[Docket No. FAA-2022-1647; Project Identifier AD-2022-01379-T]

Airworthiness Directives; Transport and Commuter Category Airplanes

ACTION: Notice of proposed rulemaking (NPRM).

Figure 1 to paragraph (g)(2) – Effective Power Spectral Density

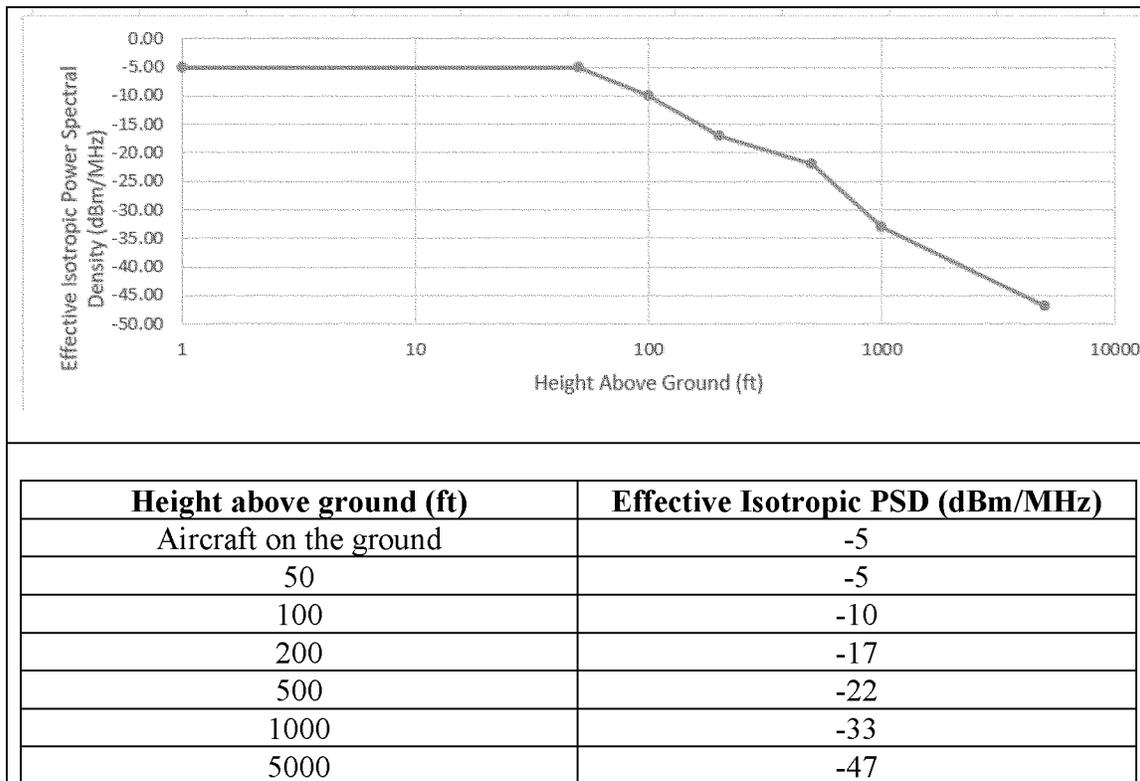
The interference tolerance requirements are represented by a power spectral density (PSD) curve. The PSD curve, as depicted in figure 1 to paragraph (g)(2) of this proposed AD, represents the height over the ground and received power from a 5G C-Band emitter, at or below which the radio altimeter is expected to function reliably, measured in decibels per megahertz. These measurements are limited to the 5G CMAs that will be listed in an FAA Domestic Notice. For purposes of this proposed AD, a “radio altimeter tolerant airplane” (also known within industry as a Group 4 airplane) is one for which the radio altimeter, as installed, demonstrates tolerance to radio altimeter interference at or above PSD curve threshold specified in figure 1 to paragraph (g)(2) of this proposed AD. A radio altimeter tolerant airplane also demonstrates tolerance to a spurious emission level of -48 dBm/MHz in the 4200–4400 MHz radio altimeter band. For purposes of this proposed AD, a “non-radio altimeter tolerant airplane” (also known in industry as a Group 1, 2, or 3 airplane) is one for which the radio altimeter, as installed, does not demonstrate those tolerances. Some radio altimeters may already demonstrate tolerance to the 5G C-Band emissions without modification. Some may need to install filters between the radio altimeter and antenna to increase a radio altimeter’s tolerance. For others, the addition of a filter will not be sufficient to address interference susceptibility; therefore, the radio altimeter will need to be replaced with an upgraded radio altimeter. The FAA has determined that radio altimeter tolerant airplanes will not experience the unsafe condition at any airport identified by the FAA as a 5G CMA in an FAA Domestic Notice.

(i) Tolerance to radio altimeter interference at or above the power spectral density (PSD) curve threshold specified in figure 1 to paragraph (g)(2) of this AD.

(ii) Tolerance to an aggregate base station conducted spurious emission level of -48 dBm/MHz in the 4200–4400 MHz radio altimeter band.

(2) For purposes of this AD, a “radio altimeter tolerant airplane” is one for which the radio altimeter, as installed, demonstrates the tolerances specified in paragraphs (g)(2)(i) and (ii) of this AD, using a method approved by the FAA.
